ADDENDUM NUMBER TWO (2)

Project: IHL #409-001
Research Lab AHU-2 Replacement
DA PN: 20057
(UMMC Bid # 3691)

ADDENDUM NO. 2

IHL# 409-001
RESEARCH LAB AHU-2 REPLACEMENT
UNIVERSITY OF MISSISSIPPI MEDICAL CENTER
JACKSON, MS
ERG P.N. 21.030

1
M401
DETAIL OF CUSTOM BUILT MODULAR AHU-2
SCALE: 1/2" = 1'-0"

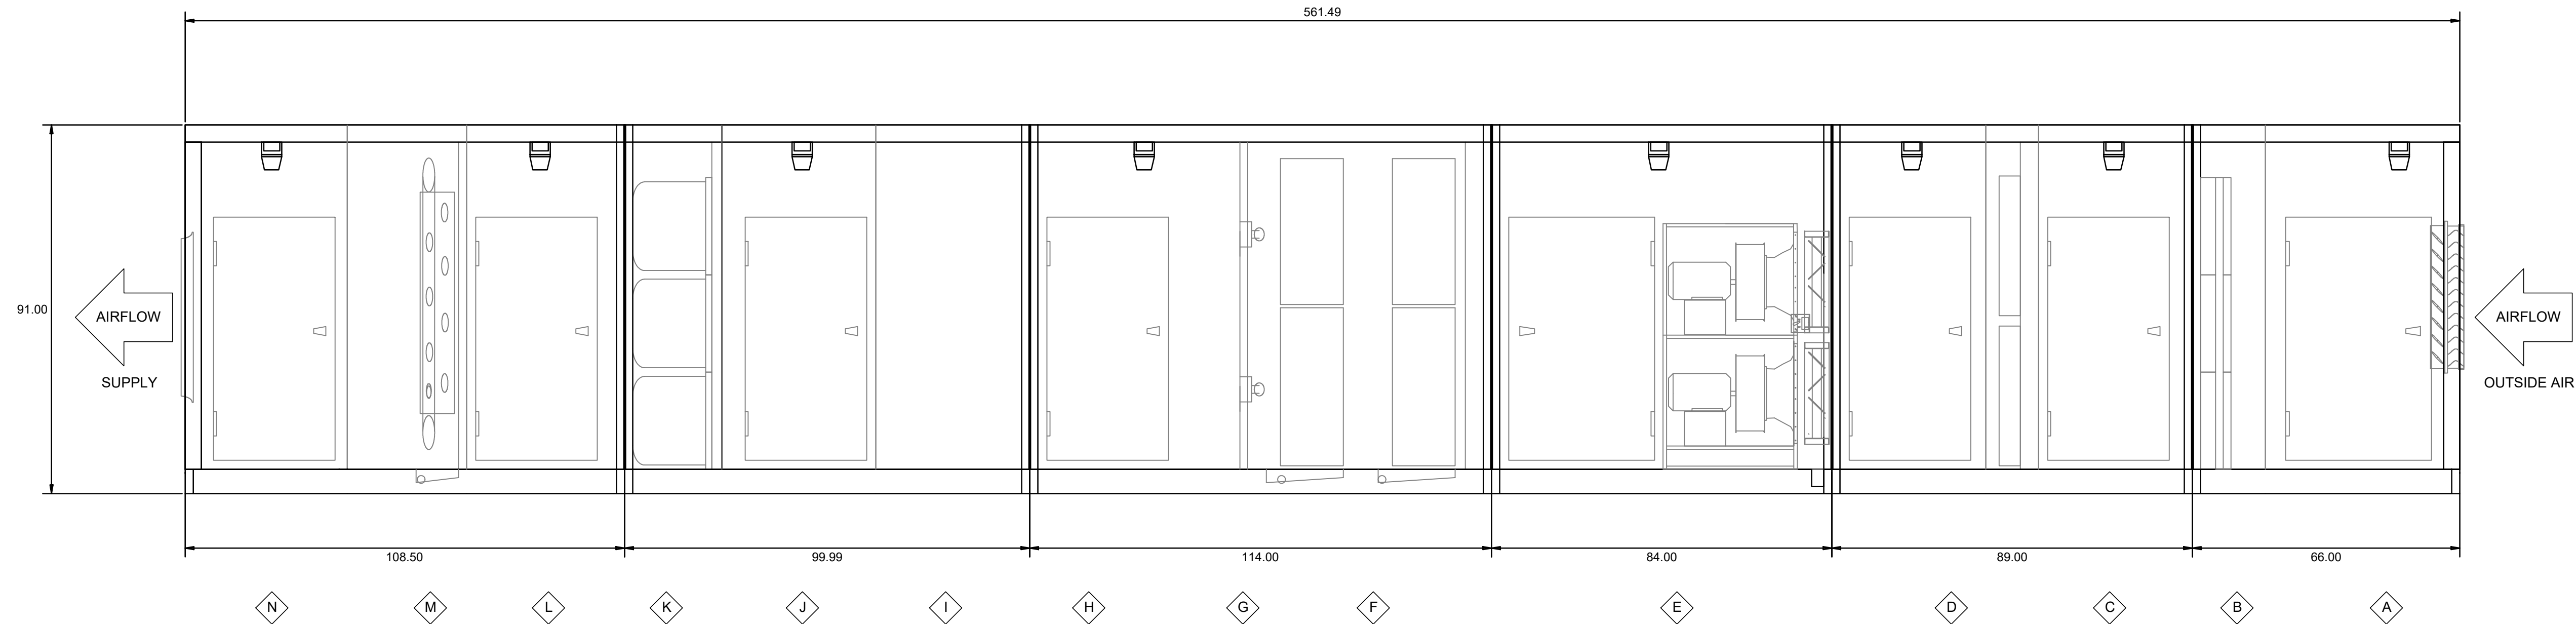
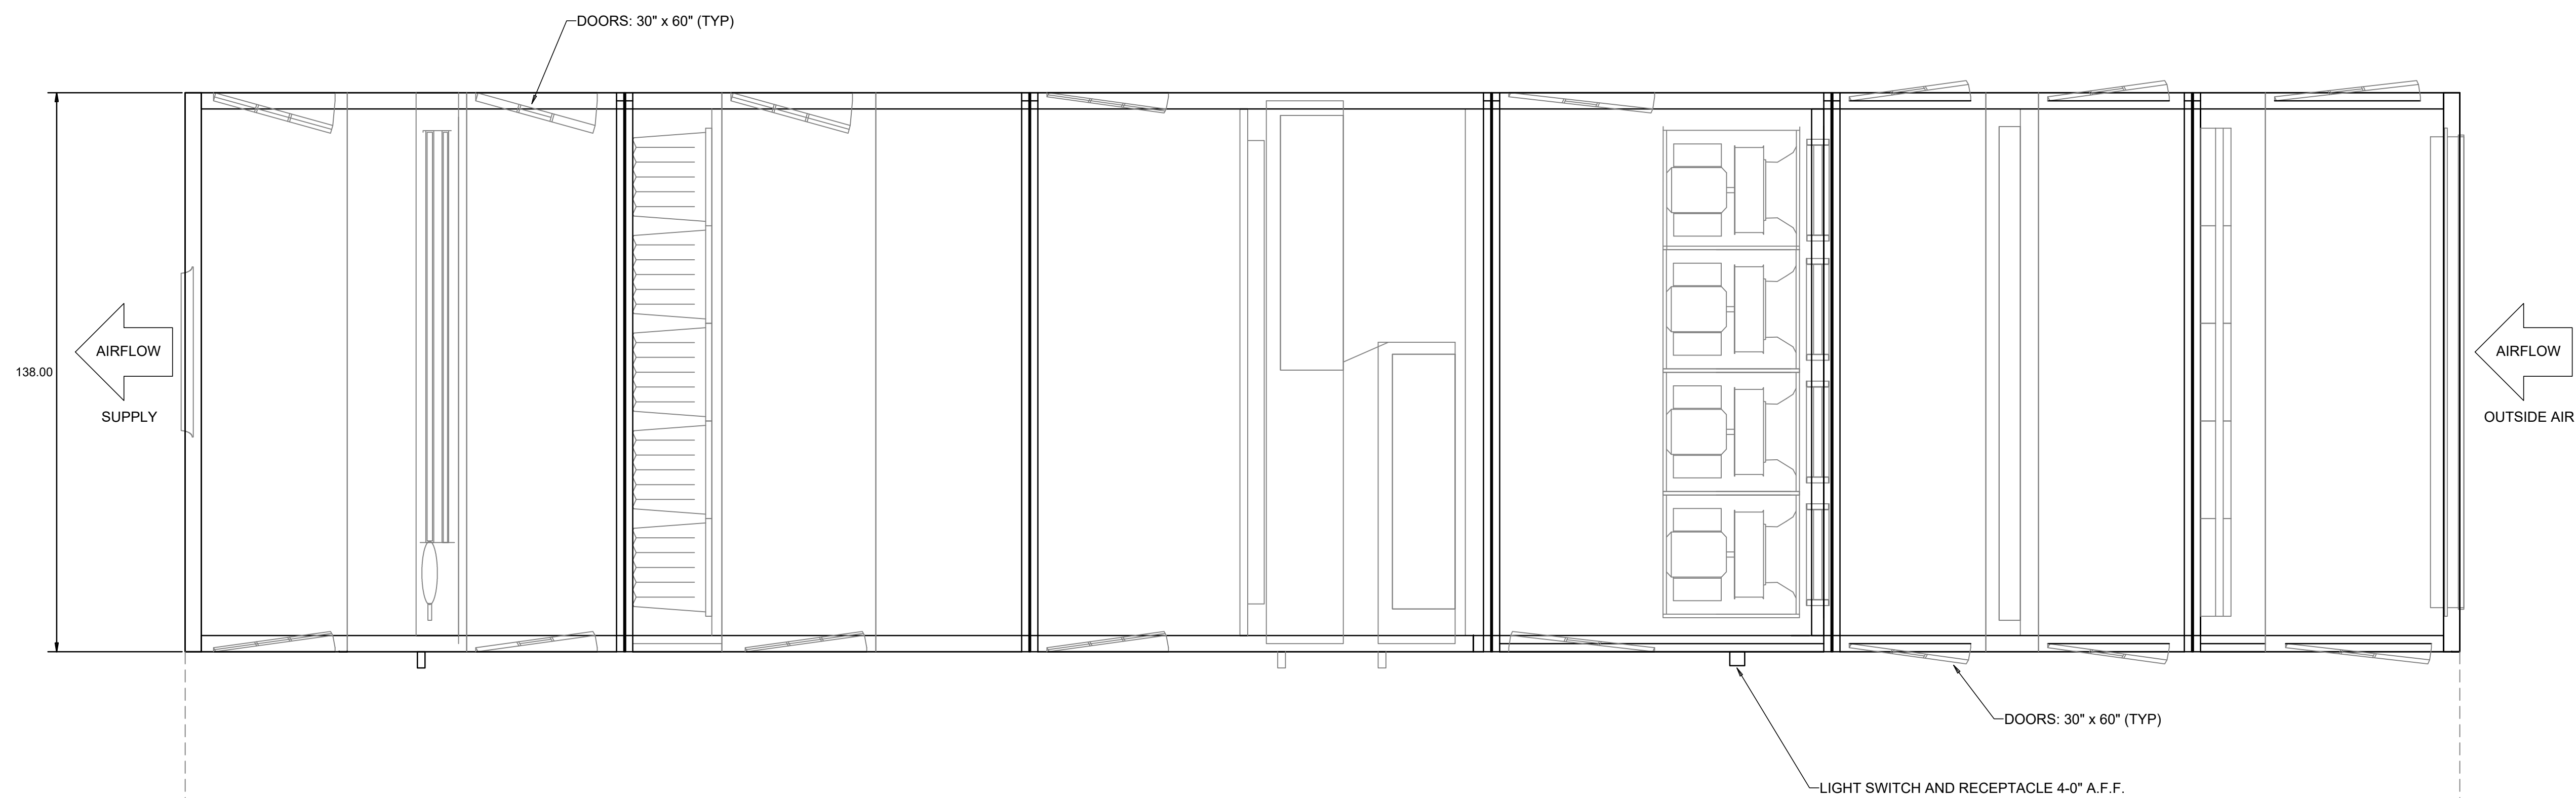
Item 3.	Reference:	237500 – Custom Air-Handling Units
	Scope:	Add the following paragraph 2.10D: D. Provide one (1) spare fan motor of same size (hp) and by same manufacturer of factory installed fan motors.

- SUPPLY FAN SECTION, (8) DIRECT-DRIVE PLENUM FANS, LED MARINE LIGHT, DUAL PANE WINDOW, MOTOR REMOVAL BEAM (SPAN WIDTH OF SECTION). FANS SHALL BE SELECTED SUCH THAT DESIGN AIRFLOW AND TSP SCHEDULED CAN BE OBTAINED WITH STABLE OPERATION WITH ONE FAN FAILED, WITHOUT REMAINING FANS OPERATING INTO MOTOR SERVICE FACTOR.
